ADDENDUM NO. 1

**EDGEMONT SCHOOL DISTRICT
GREENVILLE & SEELY PLACE SCHOOLS
HVAC UPGRADES AND CAFETERIA RENOVATIONS**

DATE: January 24, 2023

This Addendum consists of three (3) Pages, Sketch SK-A1.0, revised drawings GVES M200, GVES E101, SPES MD100, SPES M100, SPES M101, SPES M102, SPES M103, SPES M104, SPES M200, SPES M203, SPES M300, SPES M400, SPES ER100, SPES ER104, SPES E100, SPES E103, and SPES E104.

1-24-2023	ADDENDUM #1
1-06-2023	BID
DATE	ISSUED TO
SHEET SIZE: 30"x42"	DRAWING NO. SPES M200
SCALE: AS NOTED	FILE NO. 21434.01
DRAWN BY: LFG

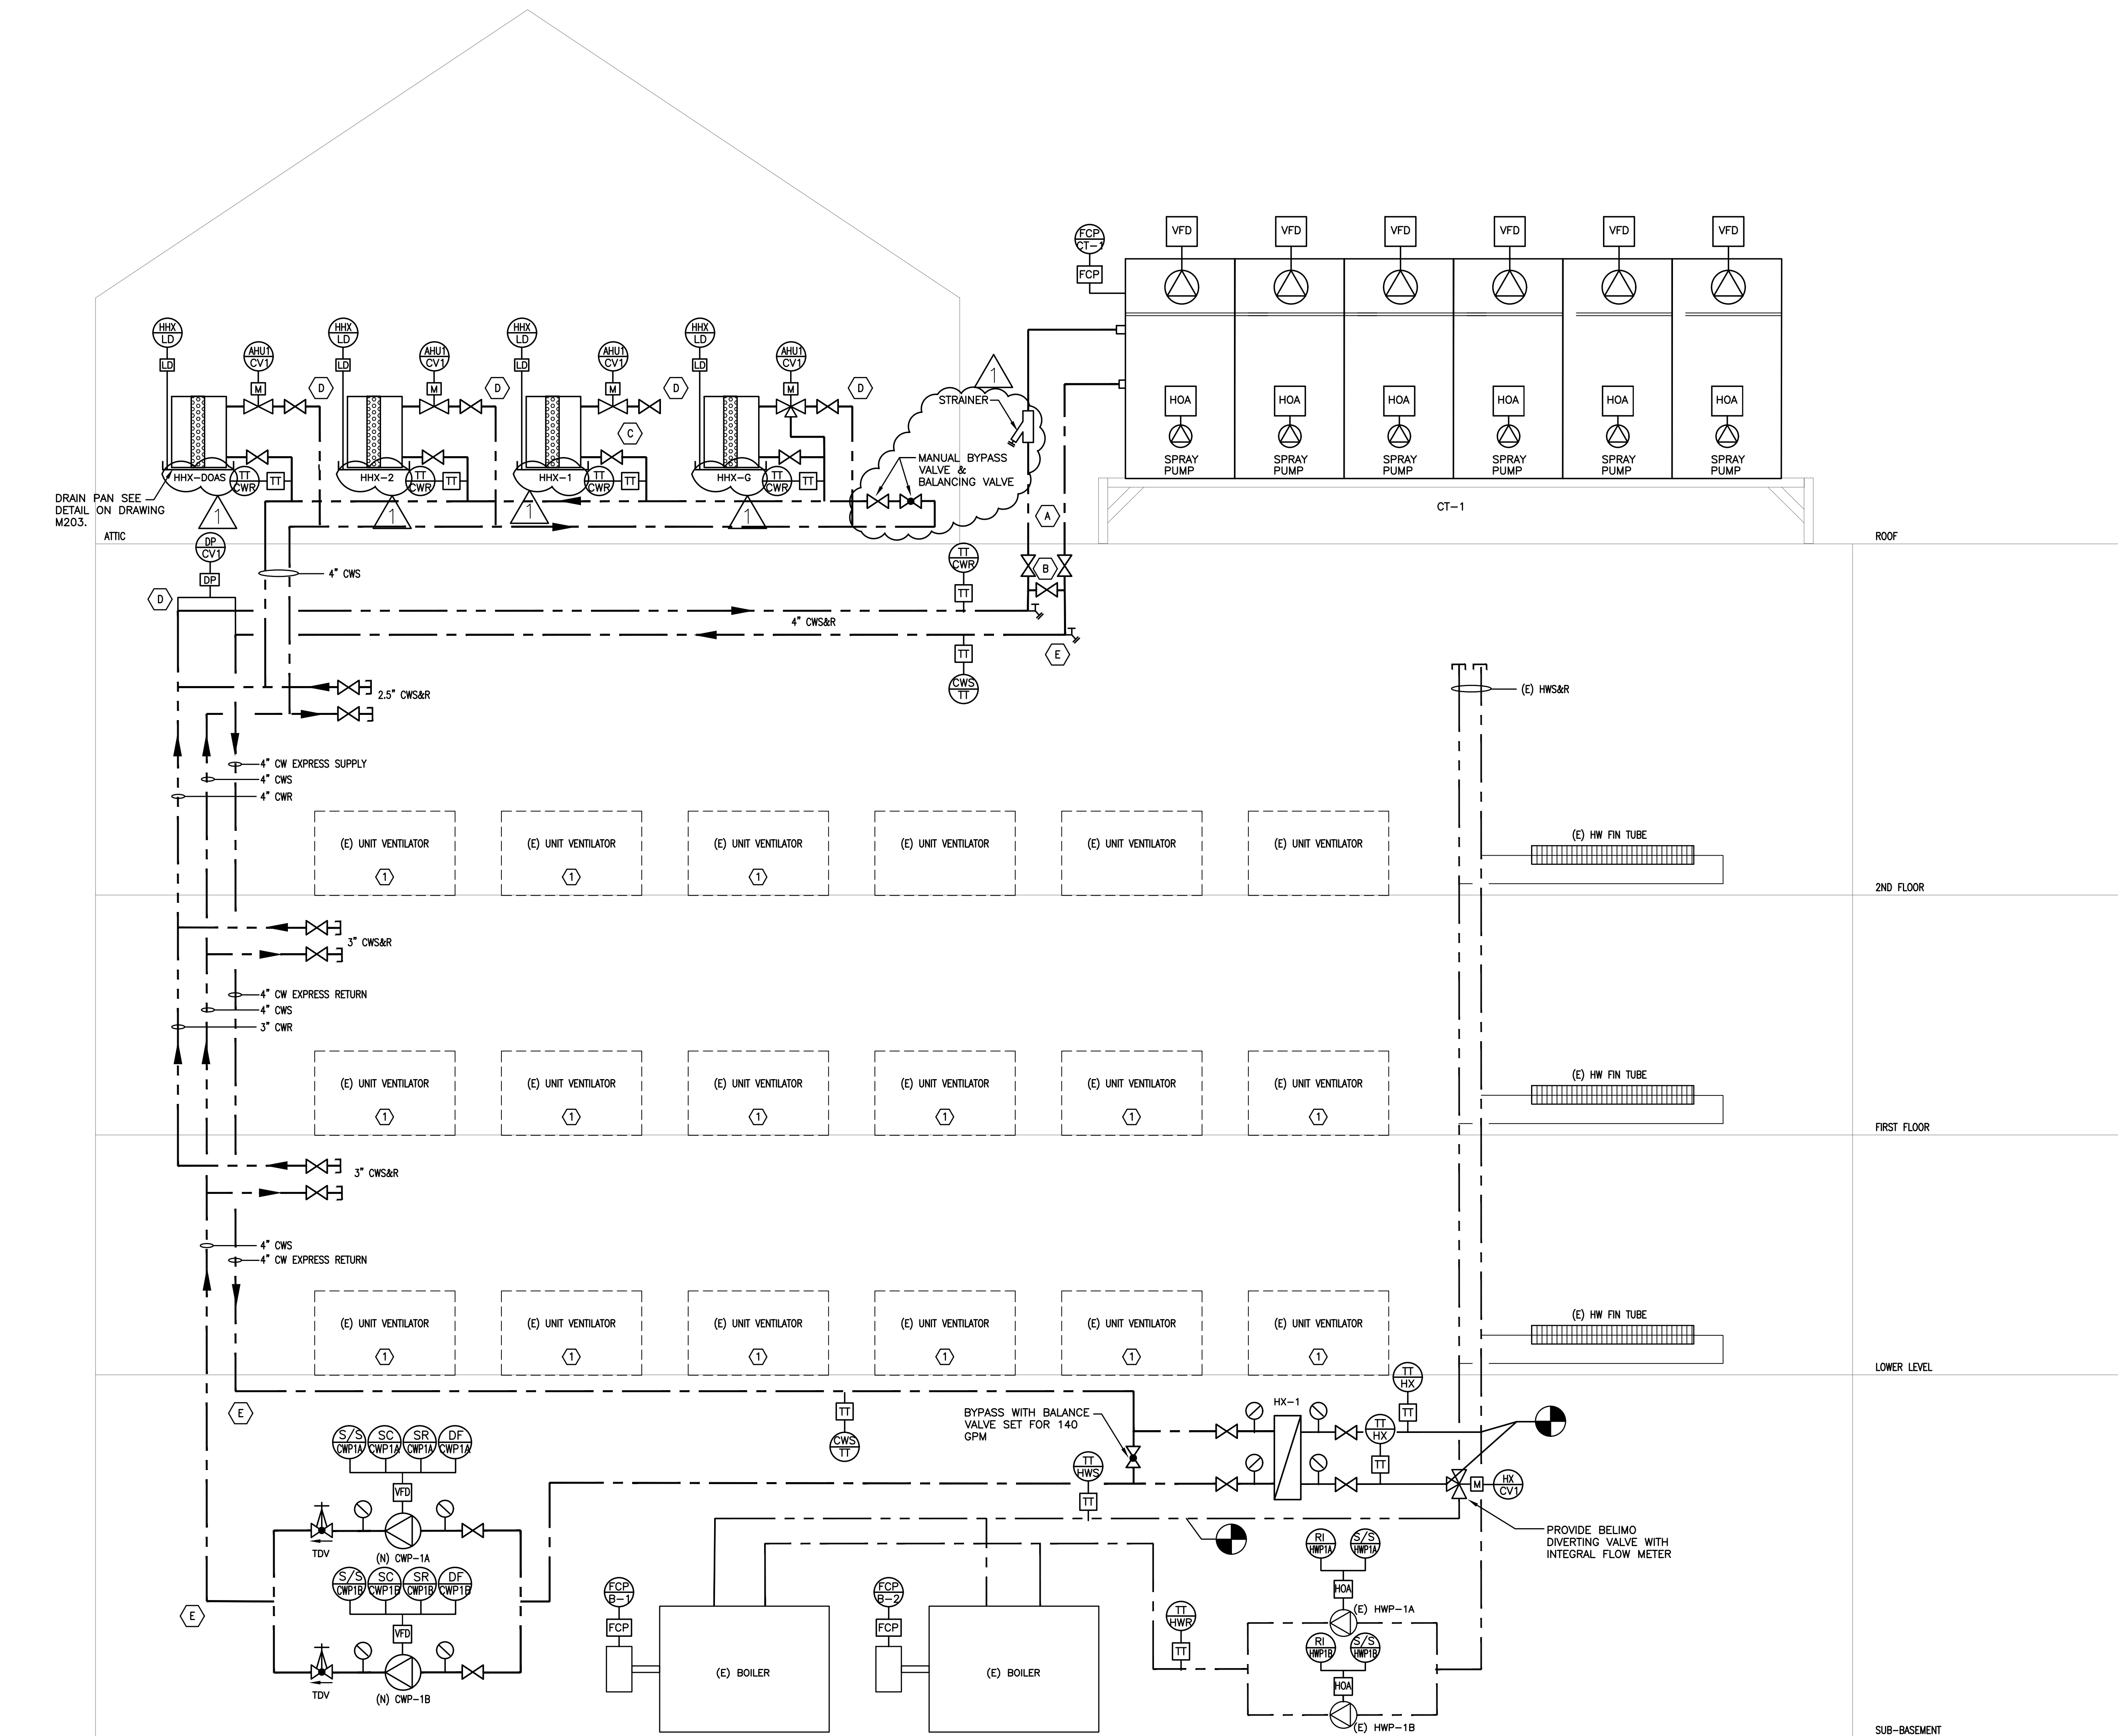
DRAWING SPES M200 – MECHANICAL PIPING & CONTROLS PLAN

ADD strainer and valves as shown on drawing attached to this addendum.

RTU-2 RETURN DUCTWORK DETAIL
NO SCALE

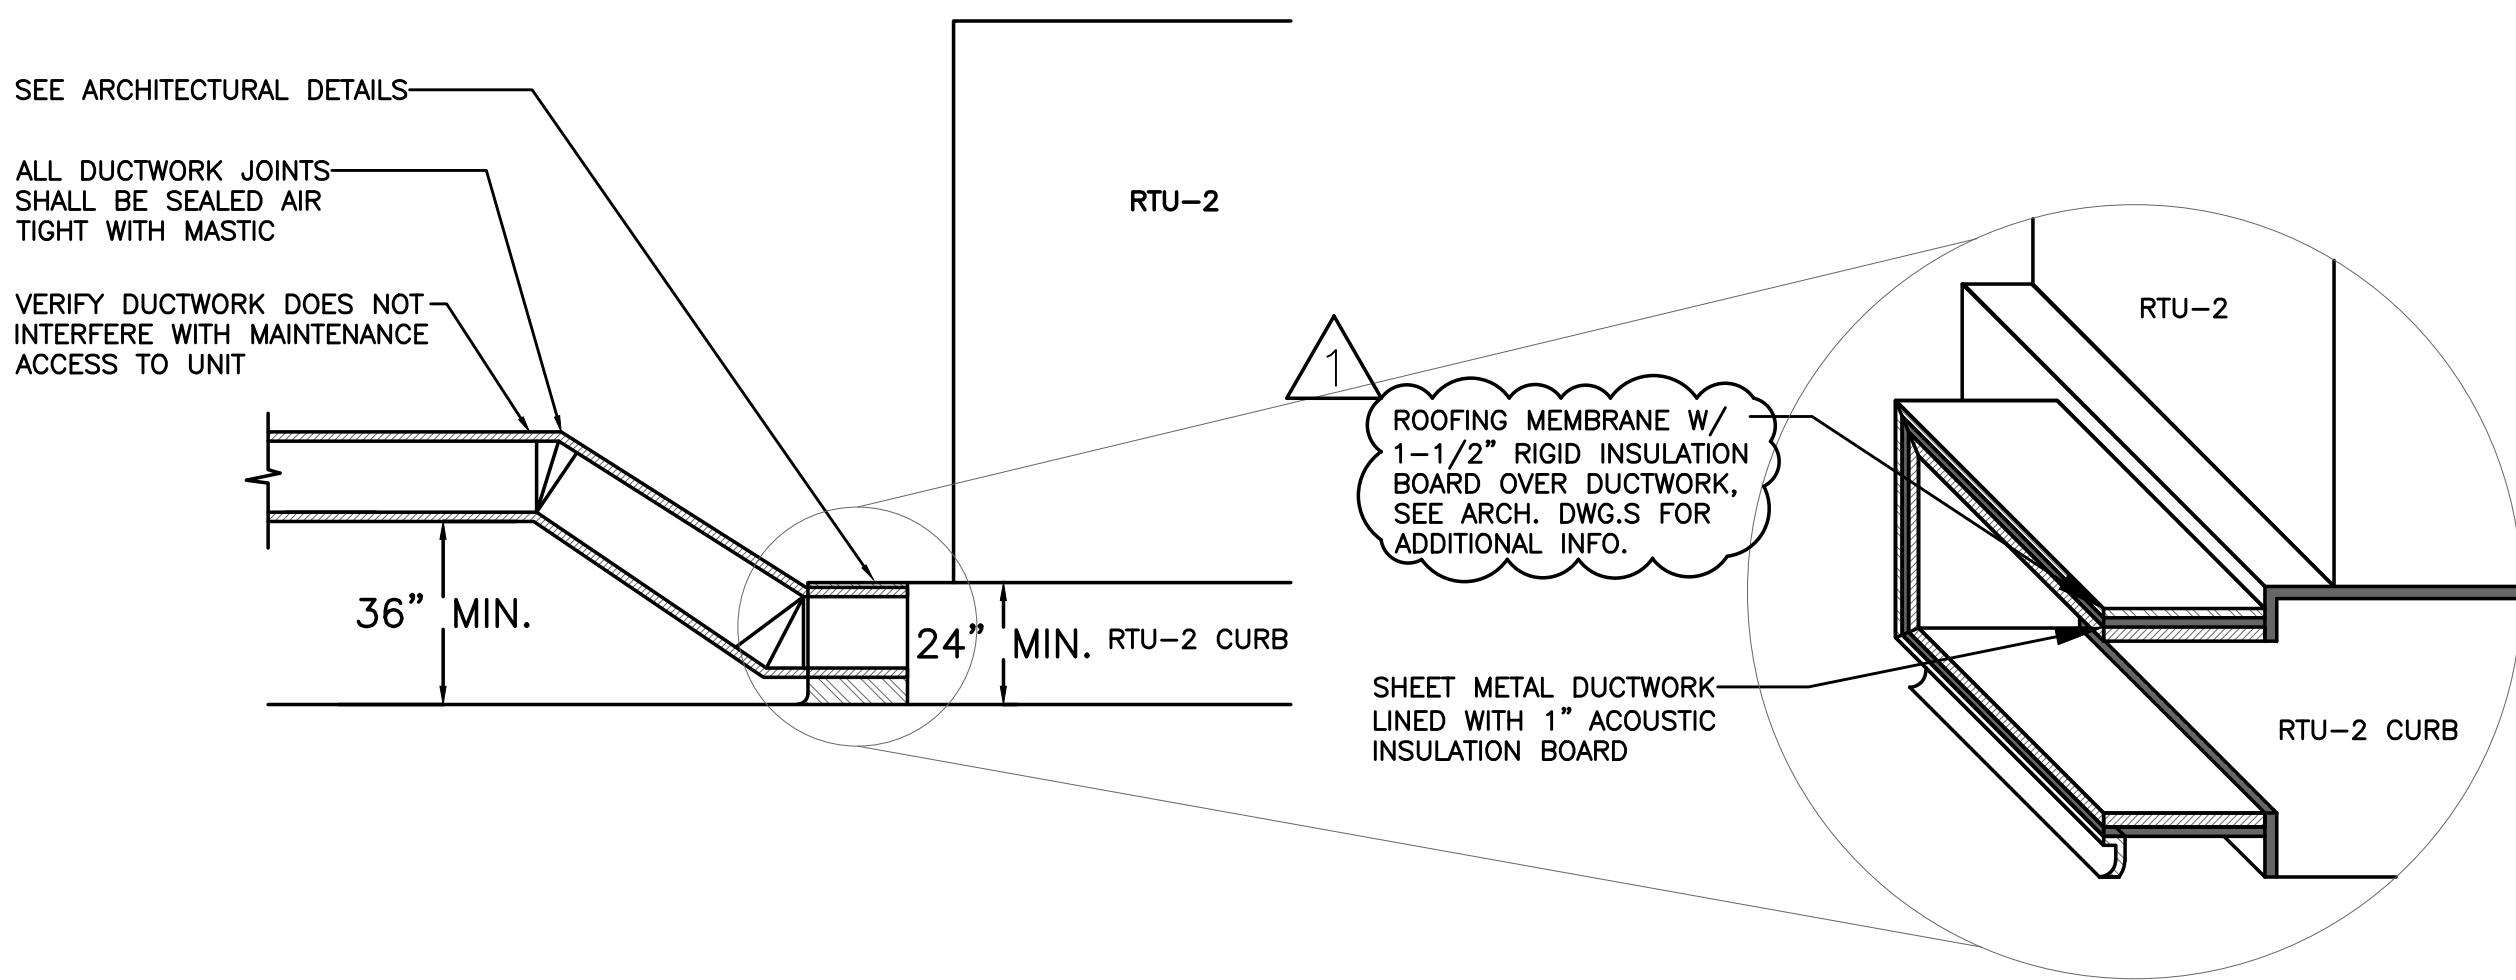
DRAWING SPES M203 – MECHANICAL DETAILS

ADD note to RTU Return Ductwork Detail as shown on drawing attached to this addendum.

1-24-2023	ADDENDUM #1
1-06-2023	BID
DATE	ISSUED TO
SHEET SIZE: 30"x42"	DRAWING NO. SPES M400
SCALE: AS NOTED	FILE NO. 21434.01
DRAWN BY: LFG

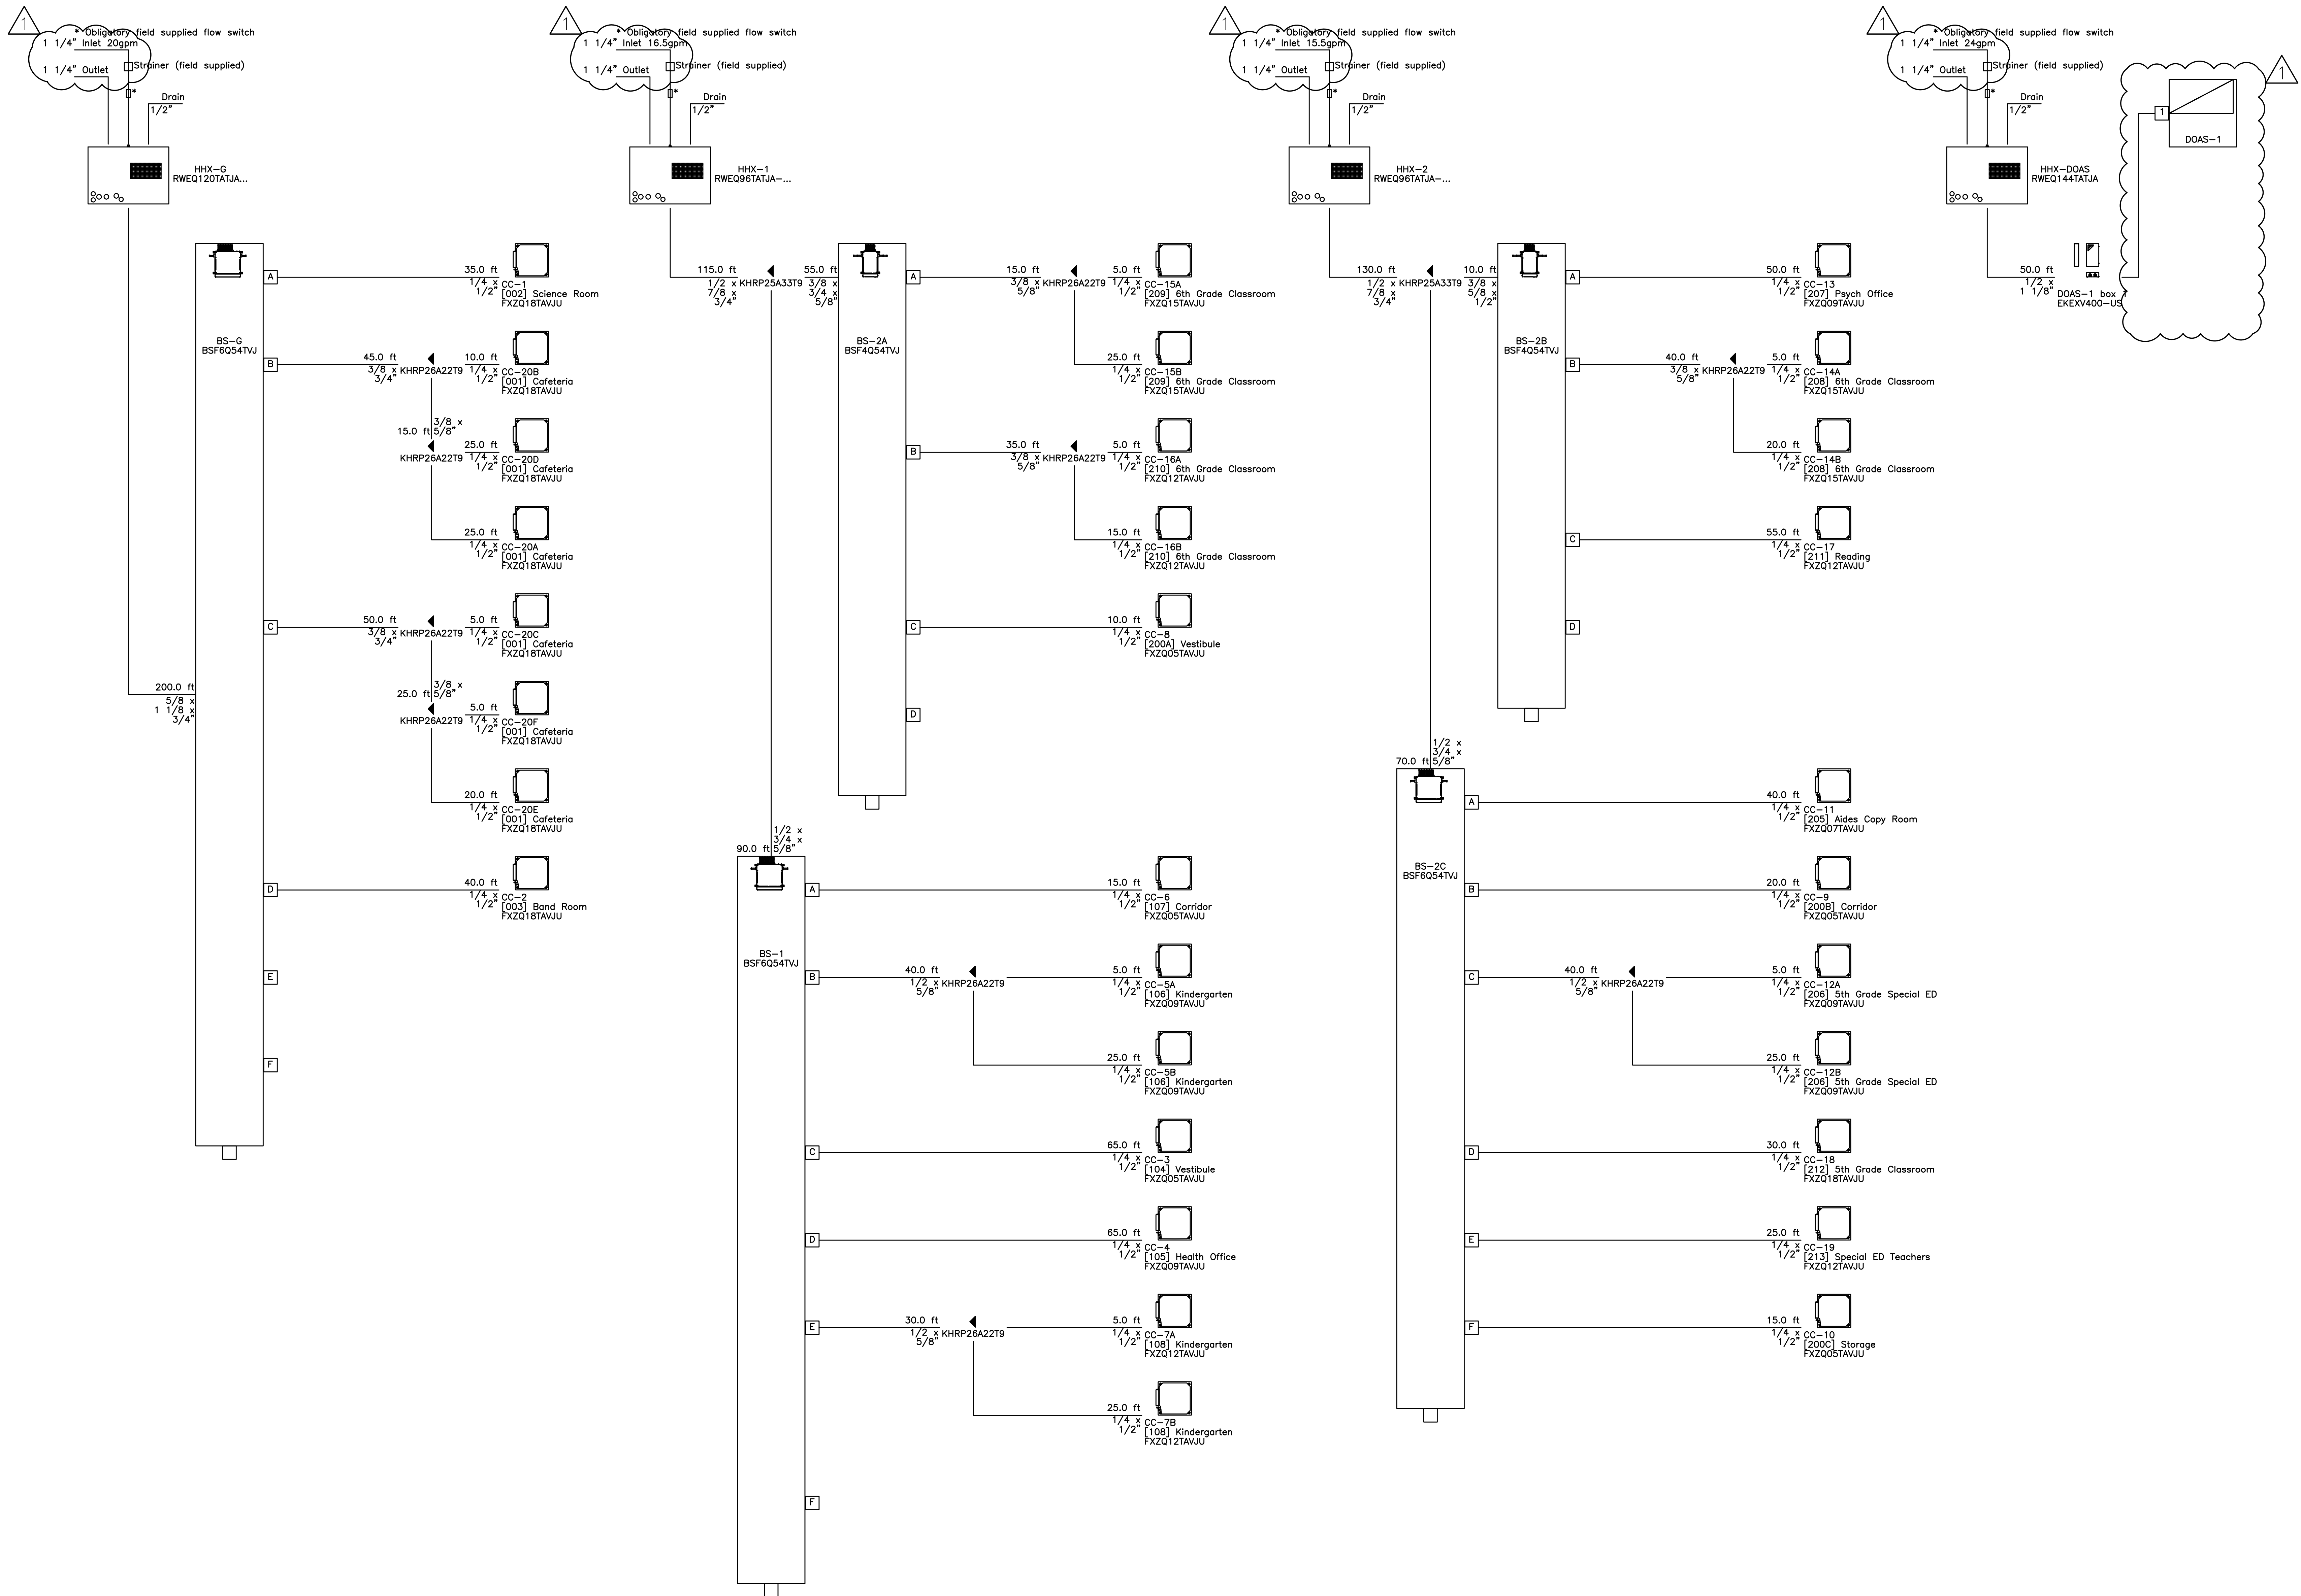
DRAWING SPES M400 – MECHANICAL PIPING DIAGRAMS

ADD inlet and outlet pipe sizes as shown on drawing attached to this addendum.
